<b>Well Name:</b> JICARILLA	<b>Well Location:</b> T24N / R4W / SEC 3 / NENE / 36.3461909 / -107.2381023	<b>County or Parish/State:</b> RIO ARRIBA / NM
<b>Well Number:</b> 1	<b>Type of Well:</b> CONVENTIONAL GAS WELL	<b>Allottee or Tribe Name:</b> JICARILLA APACHE
<b>Lease Number:</b> JIC127	<b>Unit or CA Name:</b>	<b>Unit or CA Number:</b>
<b>US Well Number:</b> 300390565700S1	<b>Operator:</b> DUGAN PRODUCTION CORPORATION

**Notice of Intent**

**Type of Action:** Plug and Abandonment

**Operator:** Dugan Production Corporation  
**Lease:** JIC127  
**Well(s):** Jicarilla 1, US Well # 30-039-05657  
**Sundry Notice ID #:** 2899732

**Planned P & A Wellbore Schematic**

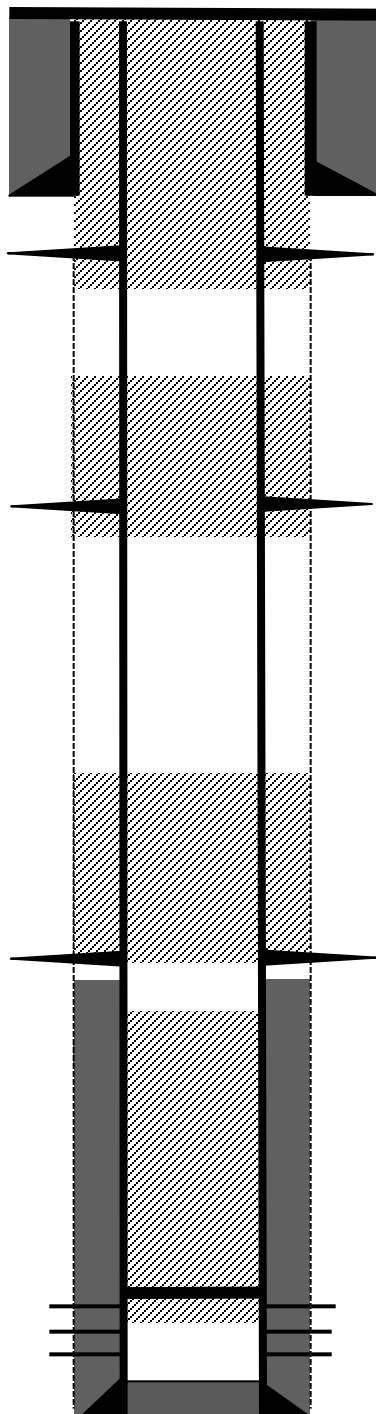
1. Plugging operations authorized are subject to the attached "General Requirements for Permanent Abandonment of Wells on Federal and Indian Lease."
2. The following modifications to your plugging program are to be made:
  - a. Modify Plug 2. Make the BOC 2910' to account for the BLM's pick for the Kirtland at 2860'. After the results of the CBL, modify perforations accordingly to cover this Kirtland formation top.
  - b. Modify Plug 3. Make the TOC 1045' to account for the BLM's pick for the Nacimiento at 1145'.
3. **Notification:** Farmington Office is to be notified at least 24 hours before the plugging operations commence at (505) 564 7750.

Modify Plug 2. Make the BOC 2910' to account for the BLM's pick for the Kirtland at 2860'. After the results of the CBL, modify perforations accordingly to cover this Kirtland formation top.

Modify Plug 3. Make the TOC 1045' to account for the BLM's pick for the Nacimiento at 1145'.
